Westminster House

Minor Material Amendment Design and Access Statement

25 November 2024

Issue 2

Level 05 Plan - Proposed

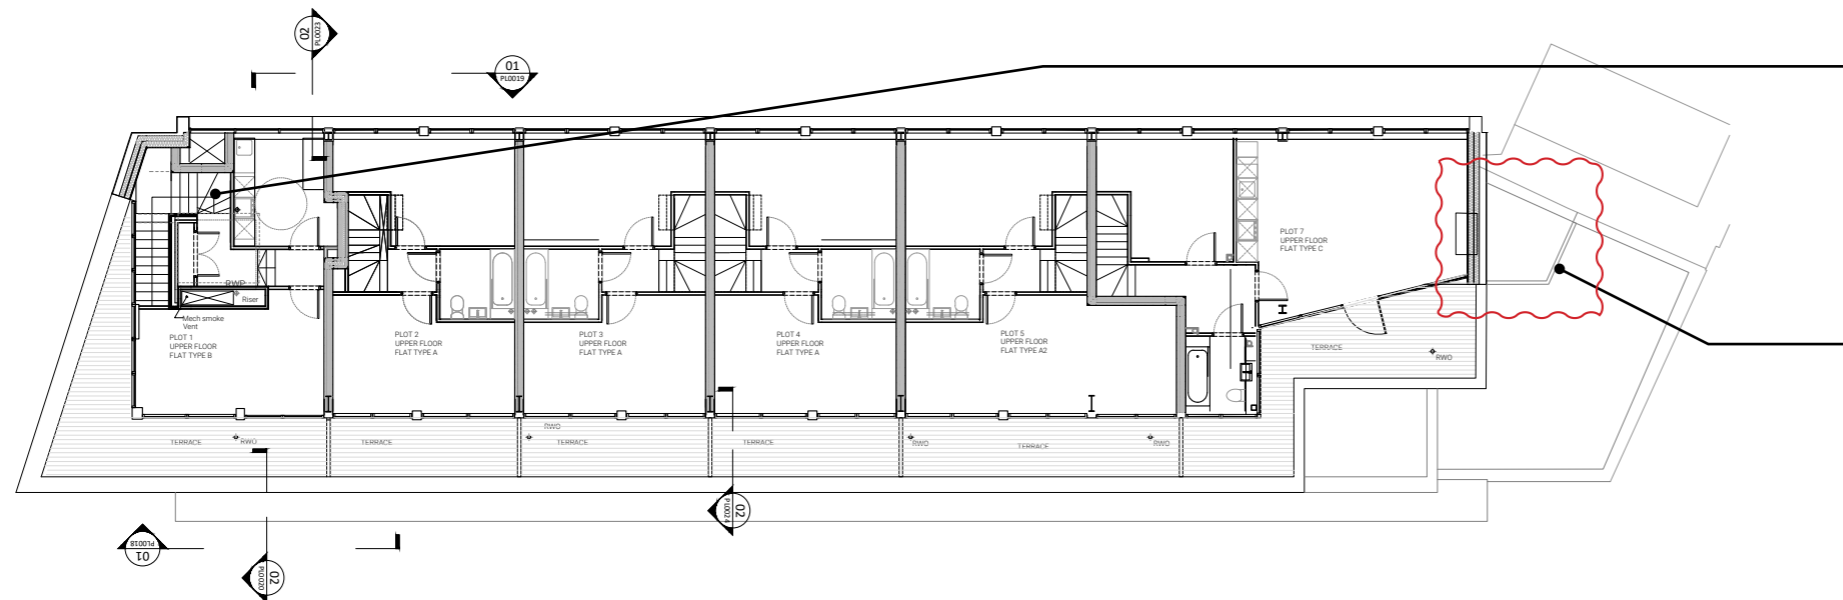
Risers to stair adjusted

Plant enclosure enlarged to cater for manufacturer confirmed smoke vent dimensions and added noise attenuation. Plant to be secured via discharge of [planning condition U0182941](#). Materials and design details to be secured via the discharge of [planning conditions BD12 and U0182935](#)

Roof Plan - Proposed

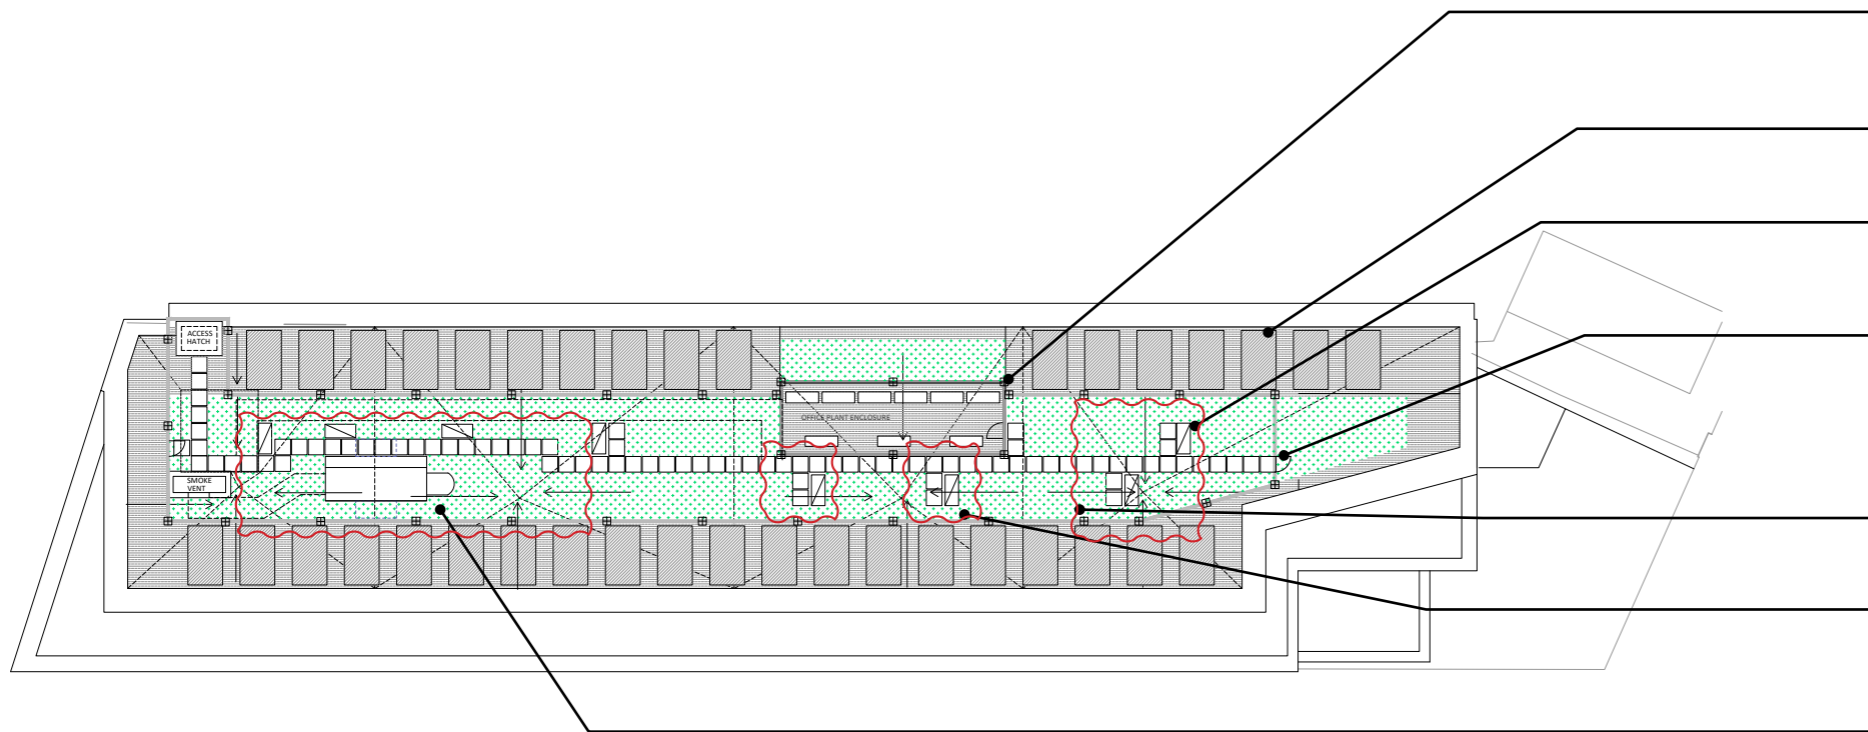
Roof access path adjusted. Plant locations shifted slightly. No reduction in green roof area

Residential air source heat pump locations adjusted. To be secured via the discharge of [planning condition U0182941](#)

Mechanical smoke vent enlarged following input from manufacturer. To be secured via the discharge of [planning condition U0182941](#)
